DATE: 07.11.2018
TO: ProTrak
FROM: Mitesh Baxi
Traffic Engineering

■ **WOODLANDS AT ECHO FARMS TRACT 3A [TRC Plan Review]**

↻ Initial Review Note ↻

Woodlands at Echo Farms Tract 3A Standard Street Lighting Plan

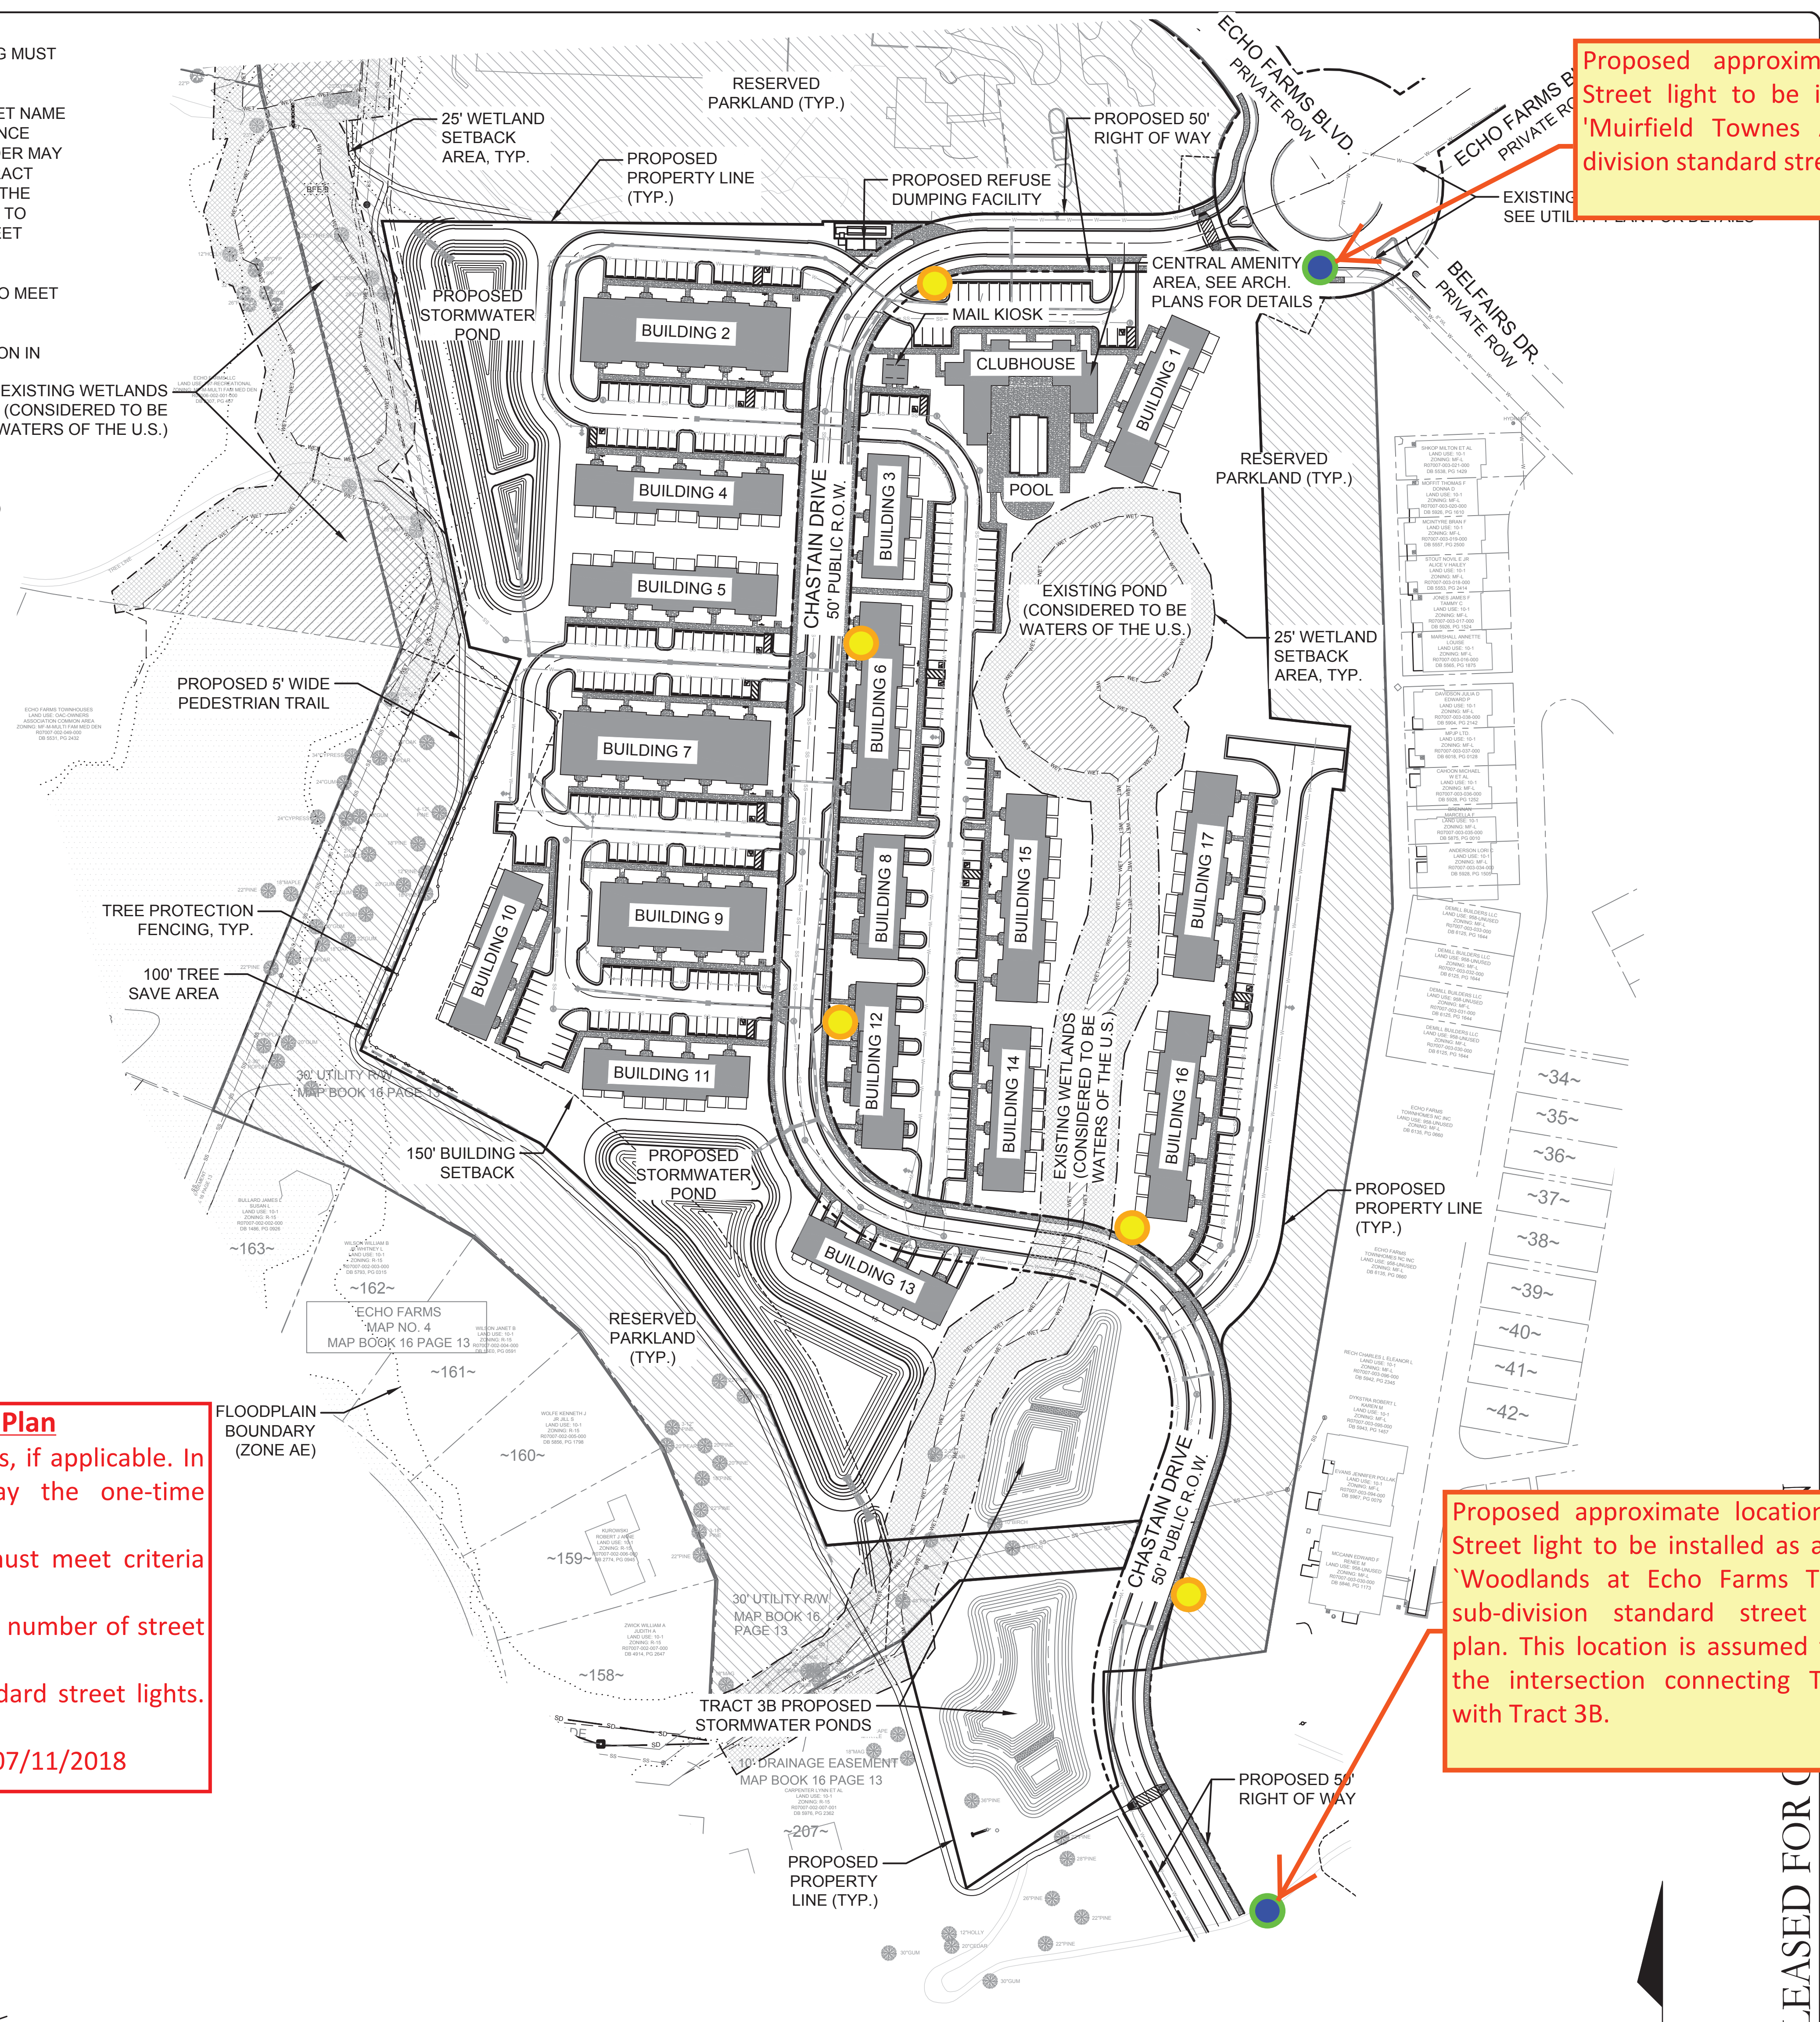
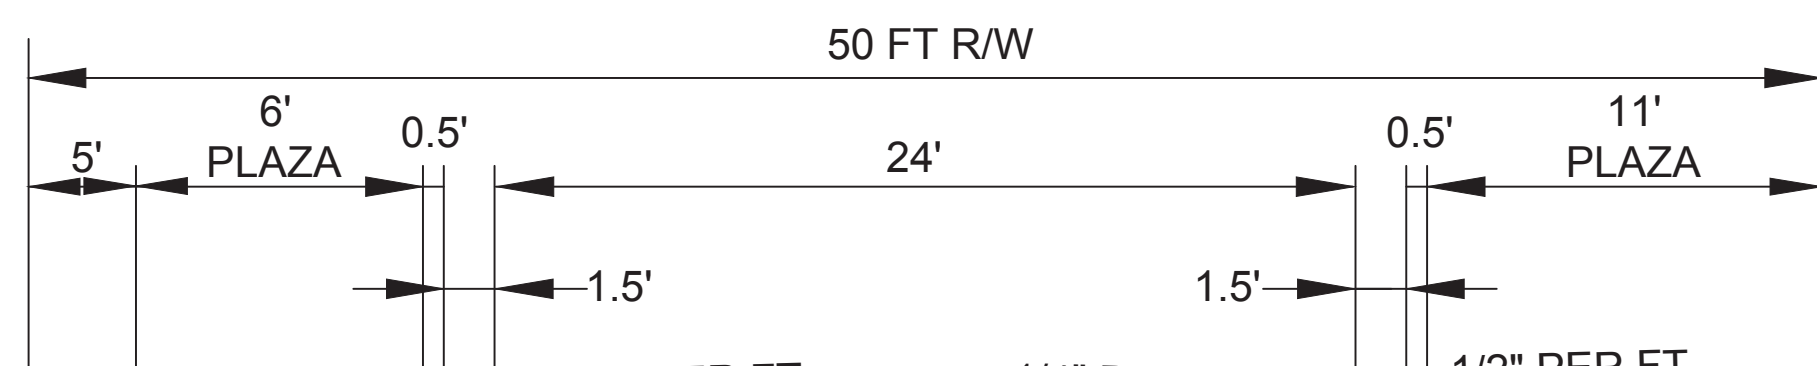
2. A layout for the Standard street lighting has been provided with the review. Minimum of *five* street lights are required for this sub-division. Although, developers may choose to provide any extra lights or ornamental. Any installations above the criteria of Standard street lighting, will be considered as non-standard and has to conform to the City's non-standard street lighting procedure as per the policy.

● Suggested approximate locations of minimum required five standard street lights. Locations may vary as per the field survey by DEP.

Proposed approximate location of the Street light to be installed as a part of 'Muirfield Townes At Echo Farms' sub-division standard street lighting plan.

Proposed approximate location of the Street light to be installed as a part of 'Woodlands at Echo Farms Tract 3B' sub-division standard street lighting plan. This location is assumed to be at the intersection connecting Tract 3A with Tract 3B.
